RAI No.	Section	Issue	Regulatory Link	Discussion	Path Forward
CH-22	Section 7.4 Sensitivity Analysis	Details of Sensitivity Analysis Not Included	10CFR20.2002(d)	Doses of 2.9 mrem for Acute Well-Driller, 3.0 mrem for Chronic Well-Driller, and 16 mrem for the Construction Intruder are provided but the details are not provided in an Attachment. Details are necessary because it is unclear what the concentration and dilution assumptions are for these scenarios.	Please provide the detailed calculations for these doses as were provided for the other scenarios.
<b>Response Summary:</b> Detailed calculations for each of the three scenarios are attached.					
<b>Response Detail:</b> In all cases the bounding concentration was based on 100 percent of the activity being from 3000 pCi/g of total uranium, with the isotopic composition based on existing sample data.

**Overall Comments on Request for Additional Alternate Disposal Approval and Exemptions for Specific Hematite Decommissioning Project Waste at US Ecology Idaho**

Sheet B to Figure 1 to Appendix G of HDP-TBD-WM-906, Sampling Results for the Process Buildings Underground Piping and Site Sewer Lines

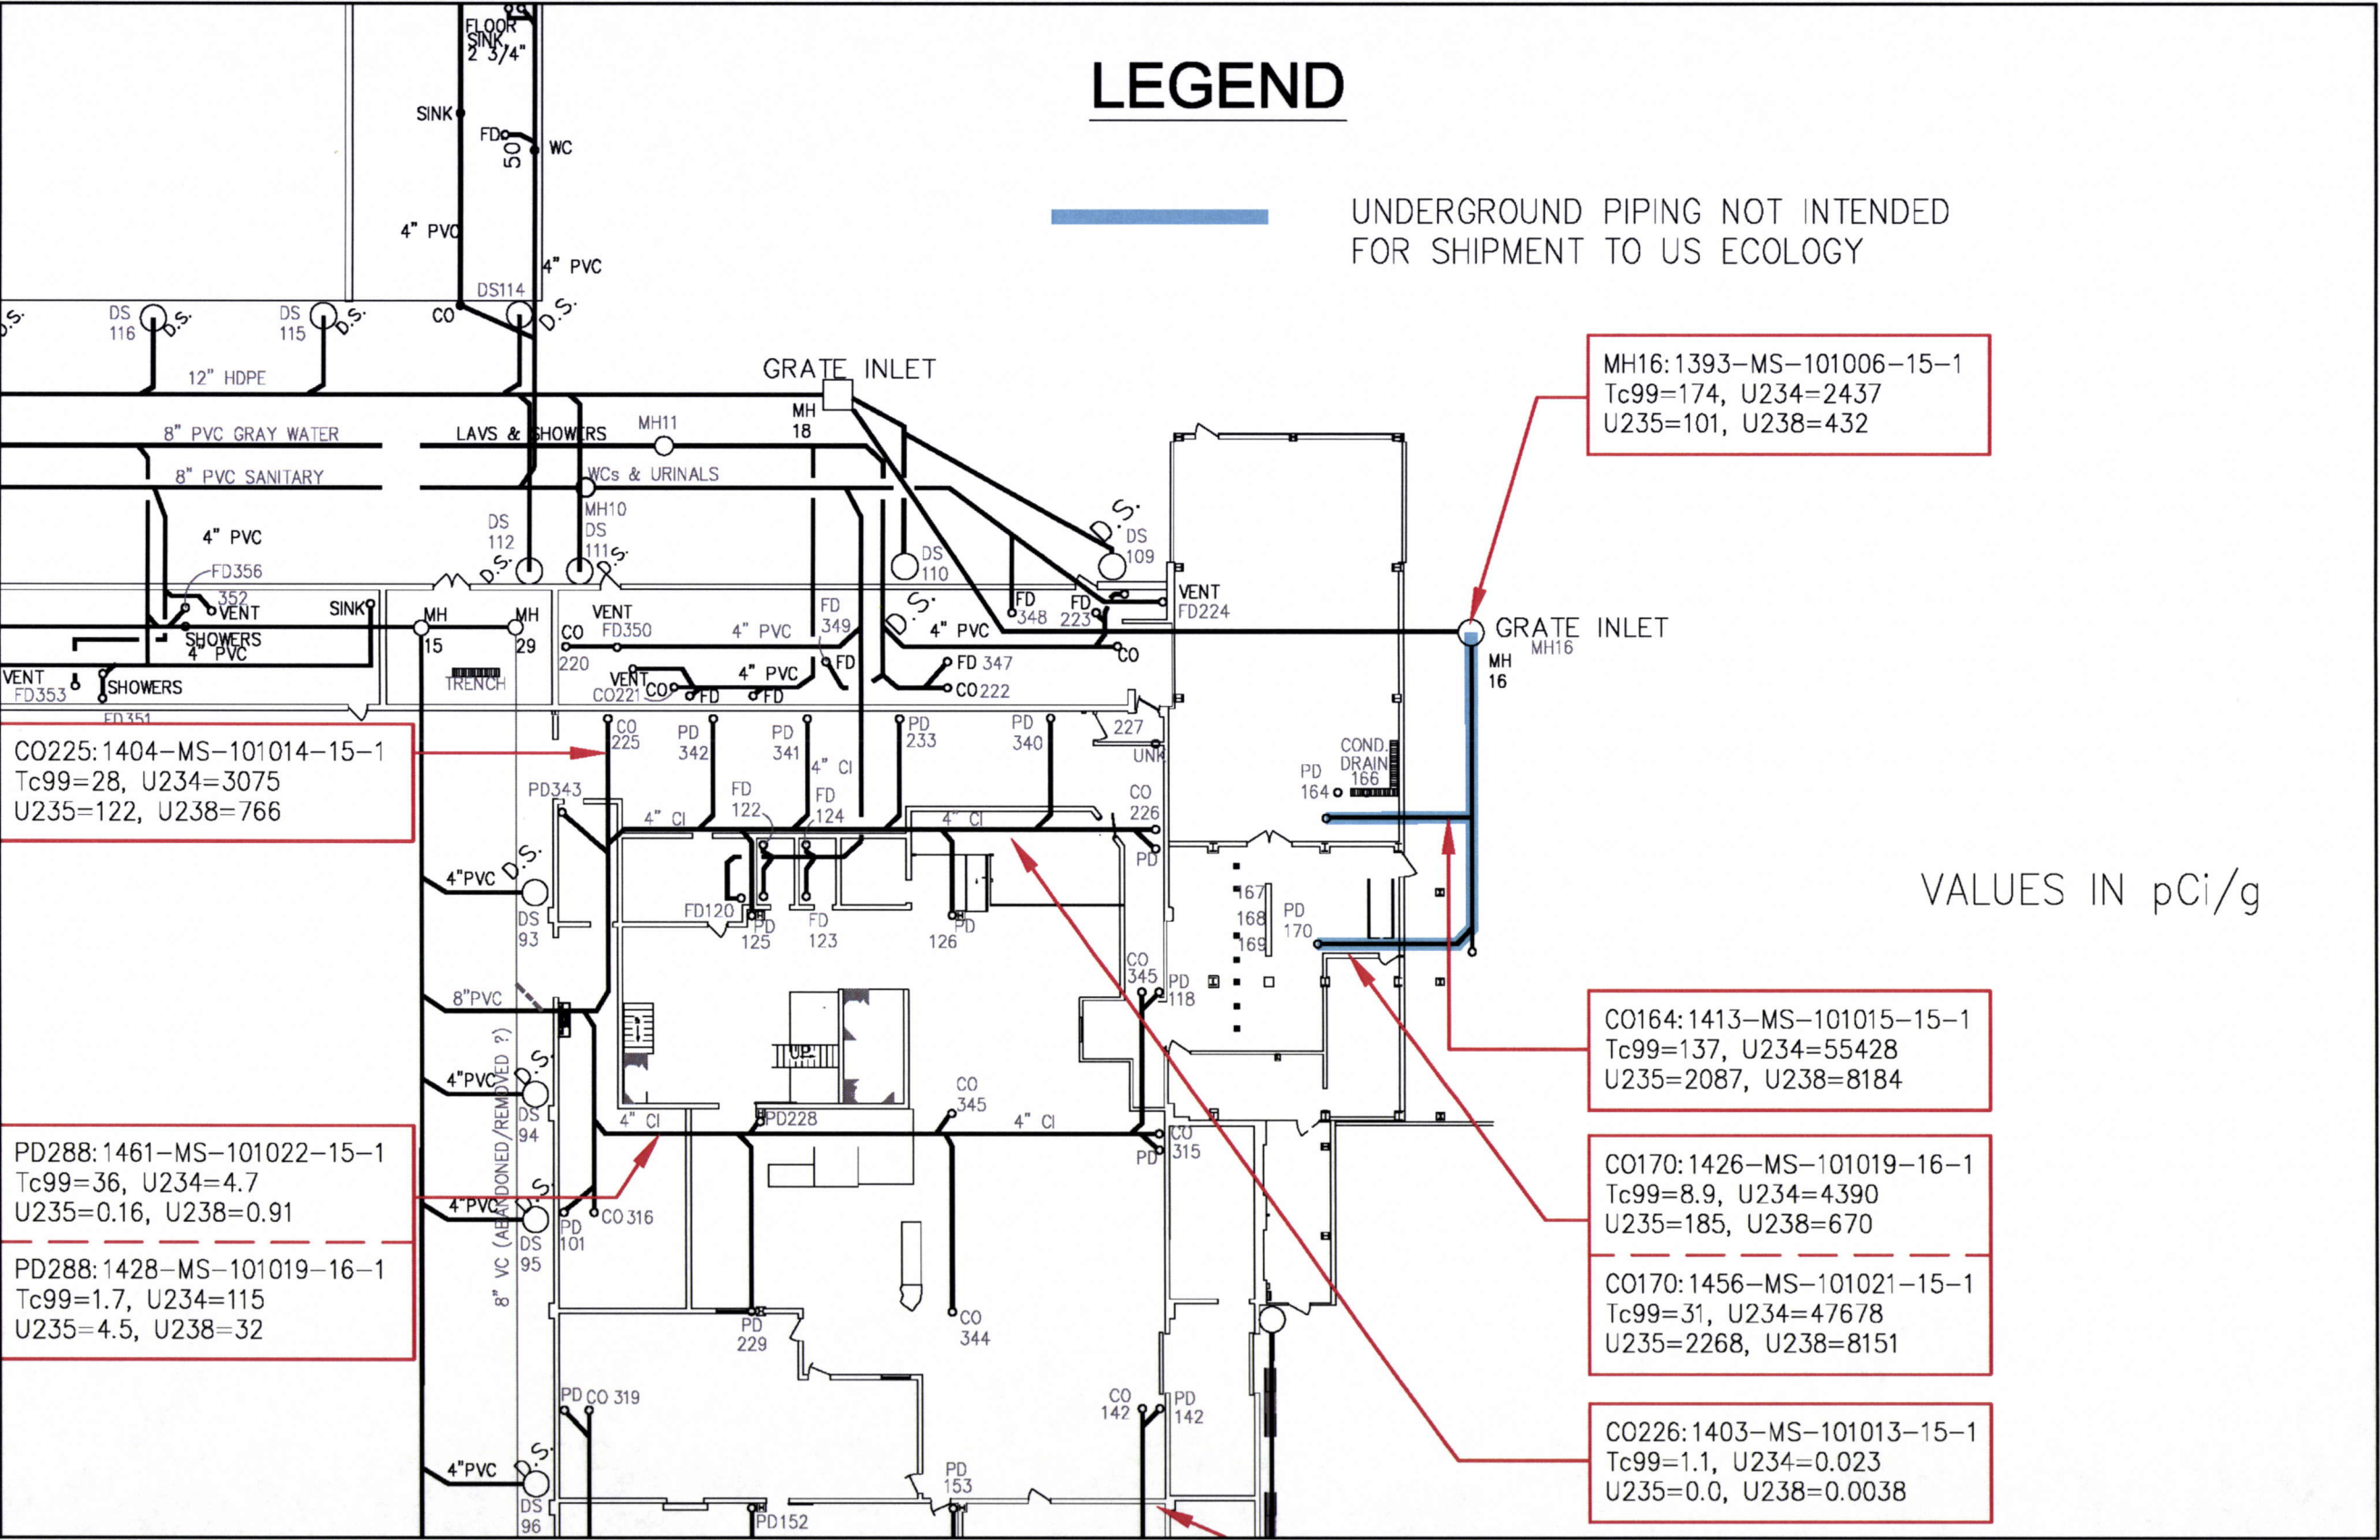
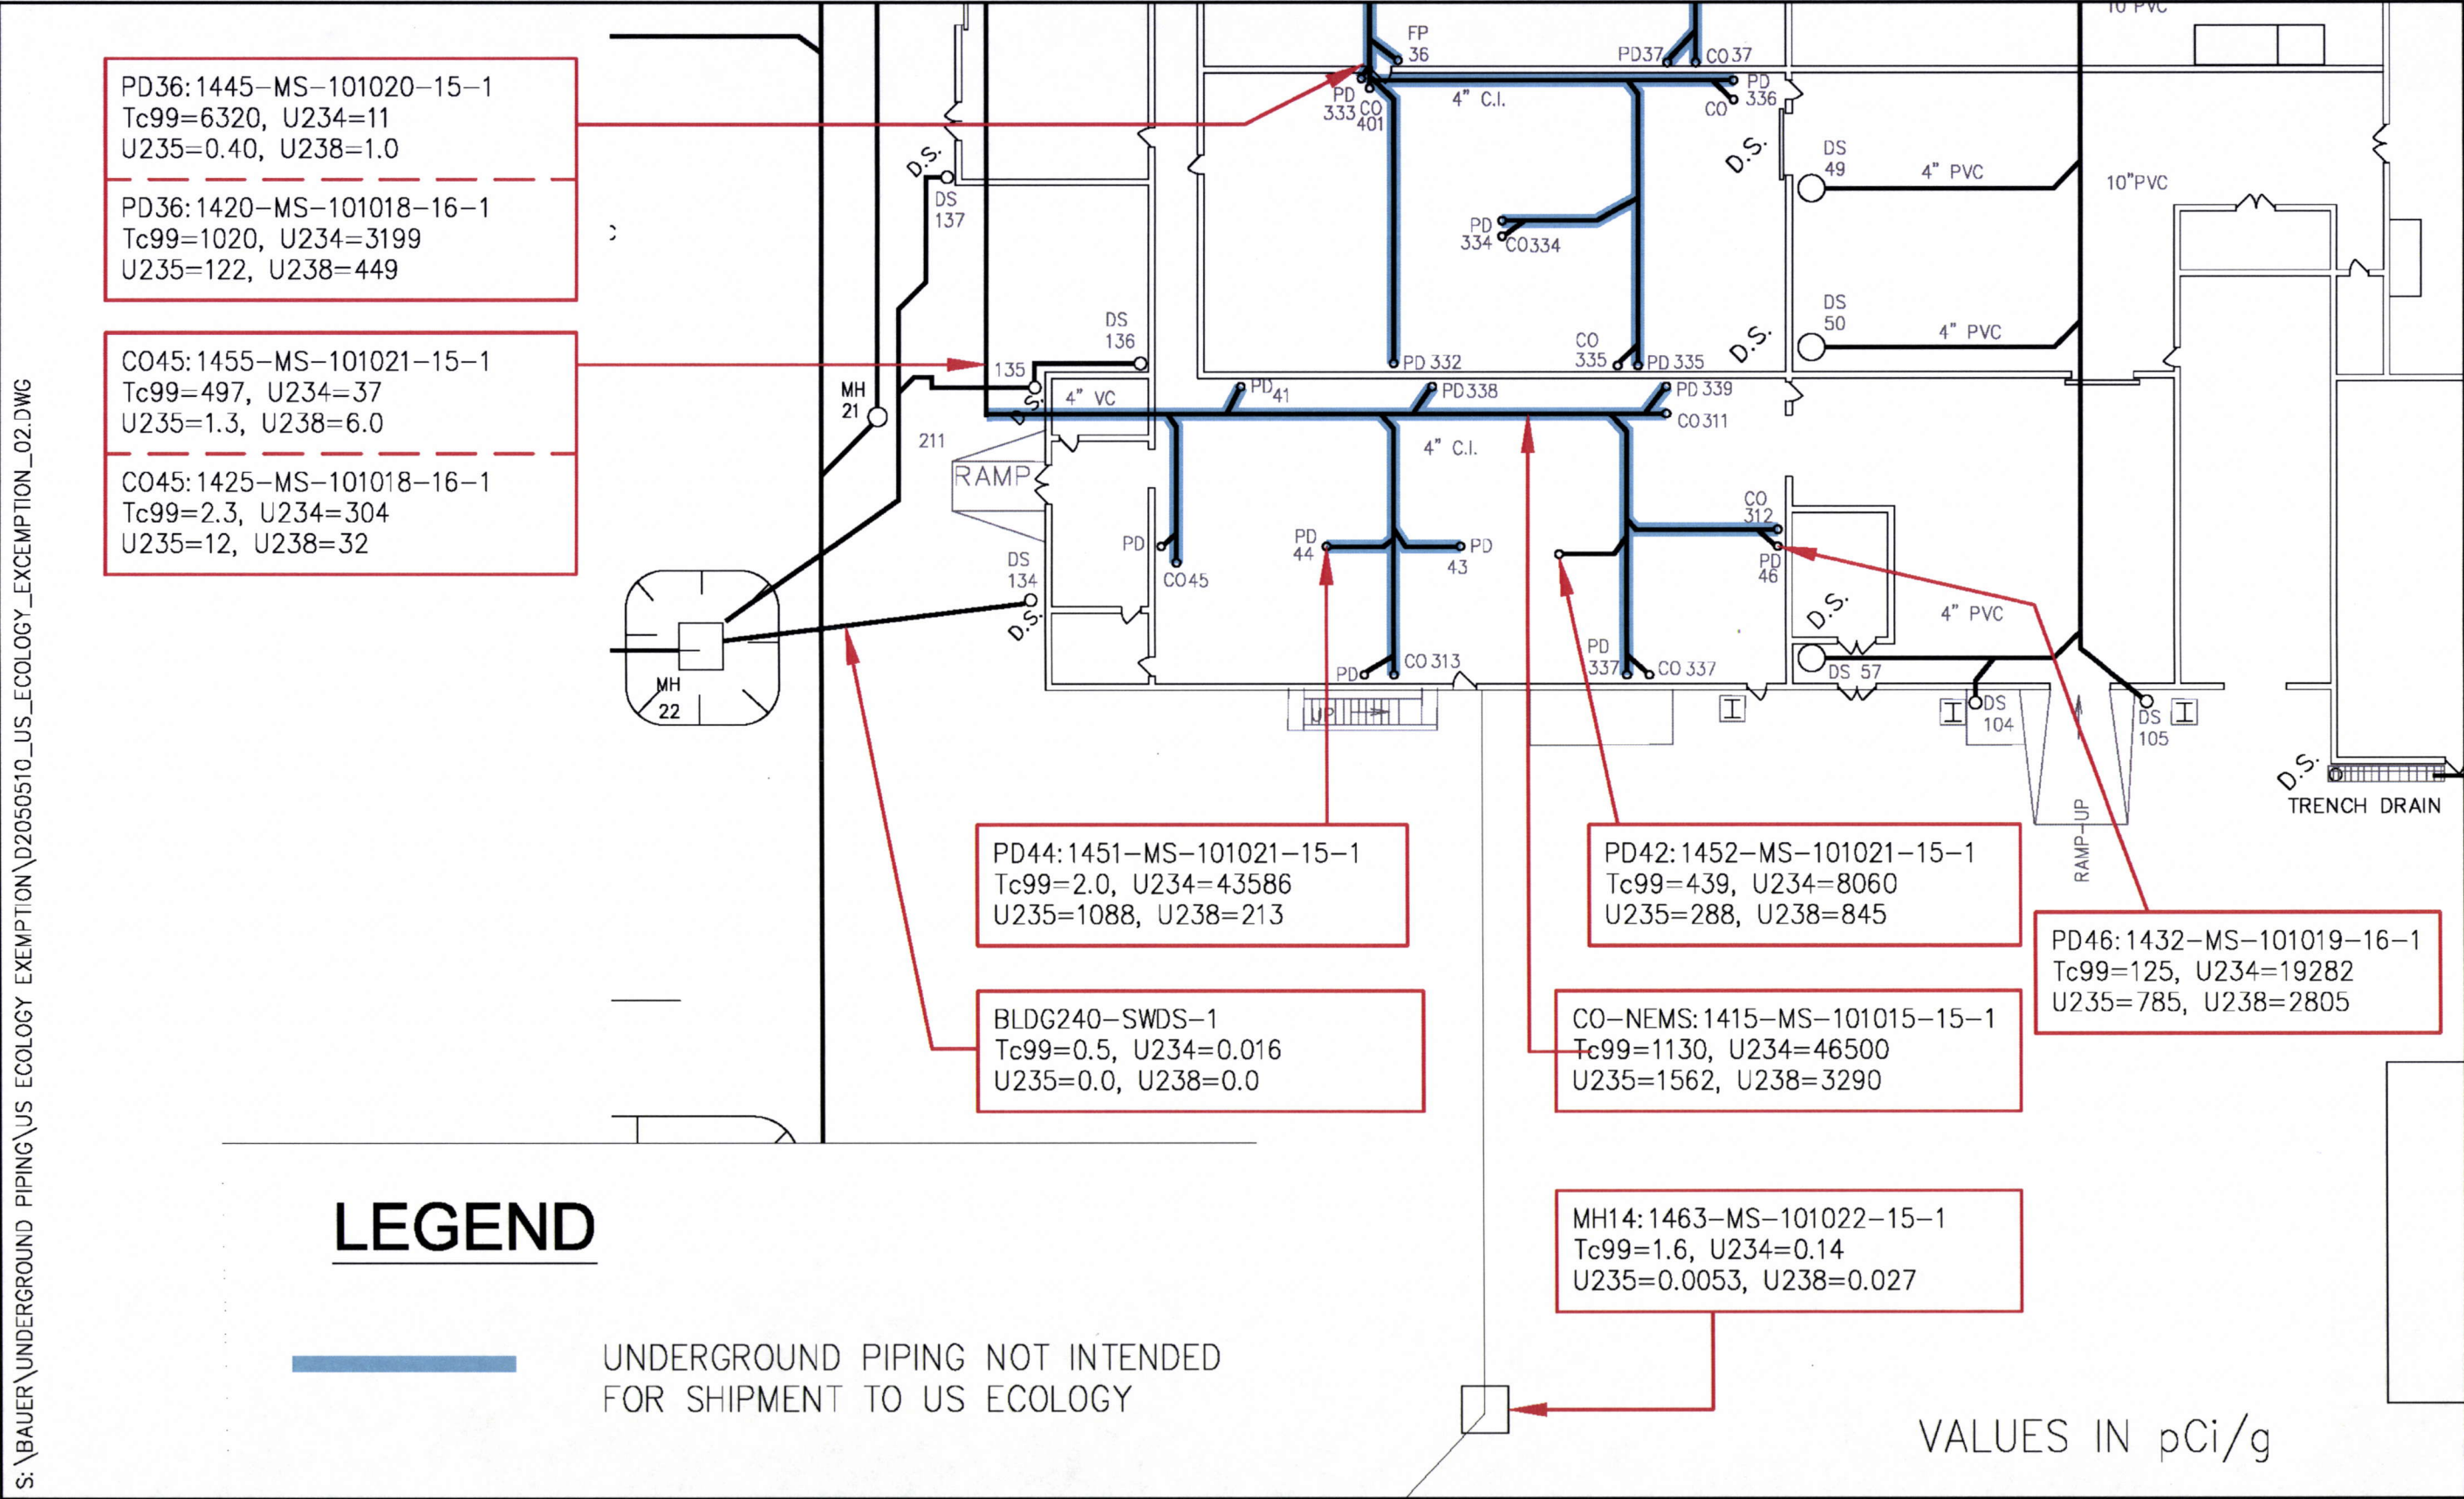
RAI No.	Section	Issue	Regulatory Link	Discussion	Path Forward
SA-7	HDP-TBD-WM-906 Section 7.1 and Appendix G	TBD Section 7.1 and App. G Figure 1 are not descriptive of piping location.	10CFR20.2002(a)	The link between piping to area and building populations is unclear.	Provide additional graphics or tables to clearly segregate piping and identify the location.
<b>Response Summary:</b> Additional graphics are provided to provide visual reference between					
<b>Response Detail:</b> Appendix F contains the specific piping included in each of the piping group designation (such as “Building 240 Middle System”) identified in Tables 7-4 and 7-5 of Section 7.1 of HDP-TBD-WM-906. In Appendix F of HDP-TBD-WM-906, the ‘From’ and ‘To/Toward’ columns contain identifiers that can be located on Figure 1 of Appendix G to HDP-TBD-WM-906 for the piping groups identified in Tables 7-4 and 7-5 of Section 7.1 of HDP-TBD-WM-906. Figure 1 to Appendix G has been broken into quadrants to facilitate it use, as provided below. A number on the figure without an associated alpha character (e.g., 203) should be read as being associated with ‘FD’ (e.g., FD 203). In some the entire words may be spelled out instead of just the alpha character (e.g., ‘204 Storm Drain’ instead of ‘SD 204’).

RAI No.	Section	Issue	Regulatory Link	Discussion	Path Forward
ENCL-5	Section 5.1	Criticality Safety Assessment, FNMCP & Physical Security	10CFR74.11	It is stated that the waste in the soil, slabs, concrete, asphalt, or HVAC equipment would consist of U-235 at enrichment levels averaging below 10%.	Provide the basis for concluding that there will be any U-235 in the soil, slabs, concrete, asphalt, or HVAC equipment enriched to levels above 5%.
<b>Response Summary:</b> Existing characterization data has identified					
<b>Response Detail:</b> Table 4-1 from HDP-TBD-WM-906 provides a summary of the average enrichment measured for each waste stream component. These range from 3.4 to 5 percent. While this represents the average enrichment, there are individual samples that indicate the presence of materials with a higher enrichment. For example, four concrete samples (1, 2B, 13 and 14) have enrichments exceeding 5 percent (8.2, 18.7, 9.4 and 15.6 percent), as listed in Table 1-2 of NSA-TR-HDP-11-11 (Attachment 10 to HEM-12-2). Other examples are internal pipe sample results listed in the figure associated with RAI SA-7 above.
